BOARD ACTION REPORT – APPEALABLE ITEM

Project Name: Kolter Hotel
Project Location: 135, 145, 169, and 185 SE 6th Avenue
Request: Class V Site Plan, Landscape Plan, and Architectural Elevations.

**SITE PLAN REVIEW AND APPEARANCE BOARD
MEMORANDUM STAFF REPORT**

Project Name: Kolter Hotel

A-5

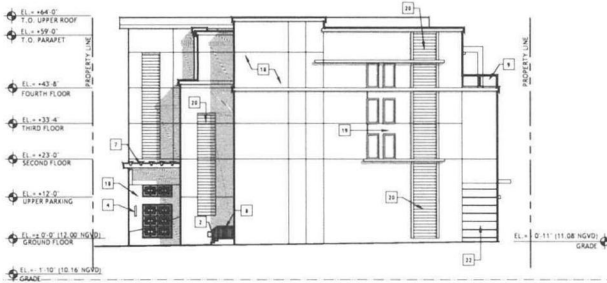
4. Lastly, The "Blank" North Façade is totally unacceptable and needs to be modified and addressed with detail, fenestration, and building undulation.
(fire rated glass can be used in this location)

C. *North Façade is essentially a "Blank Wall" and totally unacceptable-* Added Fenestration at each level (use fire glass) and added undulation/detailing are essential to make any façade visually appealing ... and imperative to the completion this design! The structure has four elevations! As proposed, it looks like the architect either forgot, or ran out of time to design the north elevation of this structure! It is unacceptable to use "zero set back" as an excuse to produce an incomplete design for our city. The north façade as proposed is an eyesore on the landscape! ... And would most likely remain exposed that way indefinitely as the property to the north is an office condominium (The Plum Building) and due to buyout economics, changes to that property, which may or may not hide the proposed un-designed façade of the Kolter hotel, are unlikely for the foreseeable future.

GROUND FLOOR

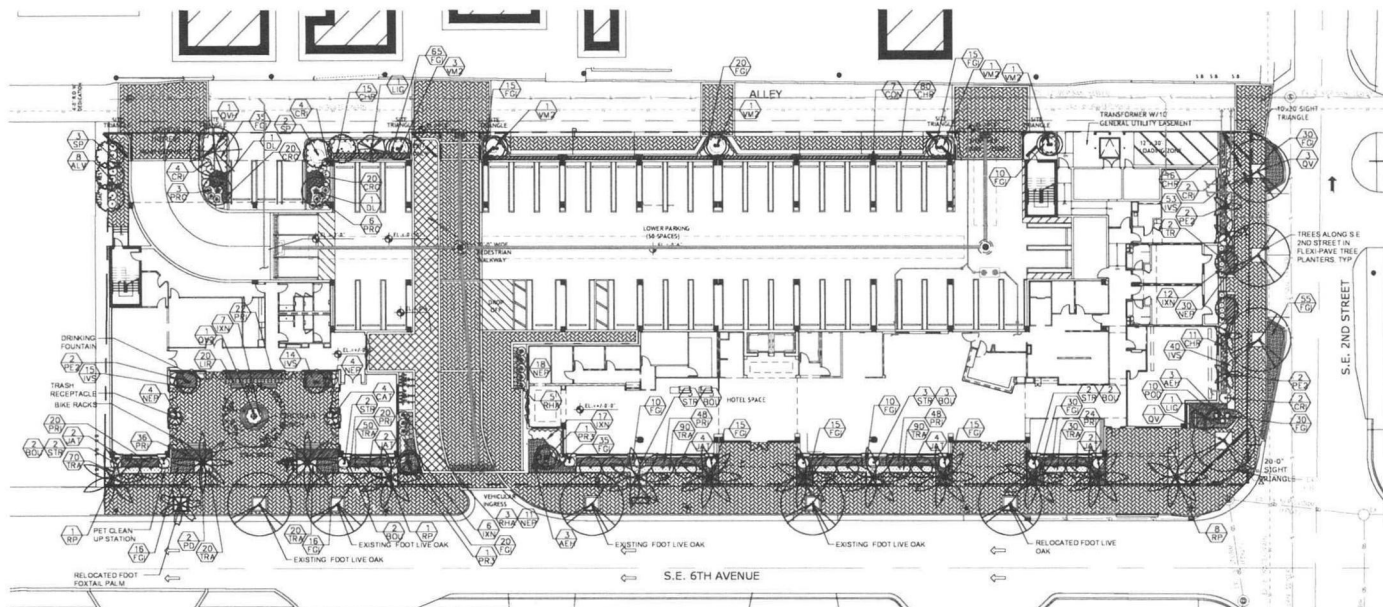
1. Replace one parallel parking space in the alley with landscaping.
2. Shield the transformer near the loading space with landscaping.
3. Add landscaping on the east side of the pool deck to help buffer the adjacent neighborhood.
4. Add additional traffic directional signage in the rear of the building/alley.

1. Alley Parallel Parking Islands- There are 6 proposed Parallel parking spaces beside the alley and as the plan has 2 parking space more than required, we would *Recommend* that 2 be removed and the 36LF of area be converted into 2 or 3 evenly sized planter islands with palms to match balance of plan.
2. Proposed Parking Spots on SE 2nd Street need to be reviewed to be compatible with prior Traffic Calming Plans for this location.

1. Alley Parallel Parking Islands- There are 6 proposed Parallel parking spaces beside the alley and as the plan has 2 parking space more than required, we would **Recommend** that 2 be removed and the 36LF of area be converted into 2 or 3 evenly sized planter islands with palms to match balance of plan.
2. Proposed Parking Spots on SE 2nd Street need to be reviewed to be compatible with prior Traffic Calming Plans for this location.

1. The final Landscape Plan reflects two-way access from Federal Highway.
2. A tree that offers more foliage such as Pigeon Plum, Magnolia, or Dahoon Holly be planted in the alley instead of a palm species.
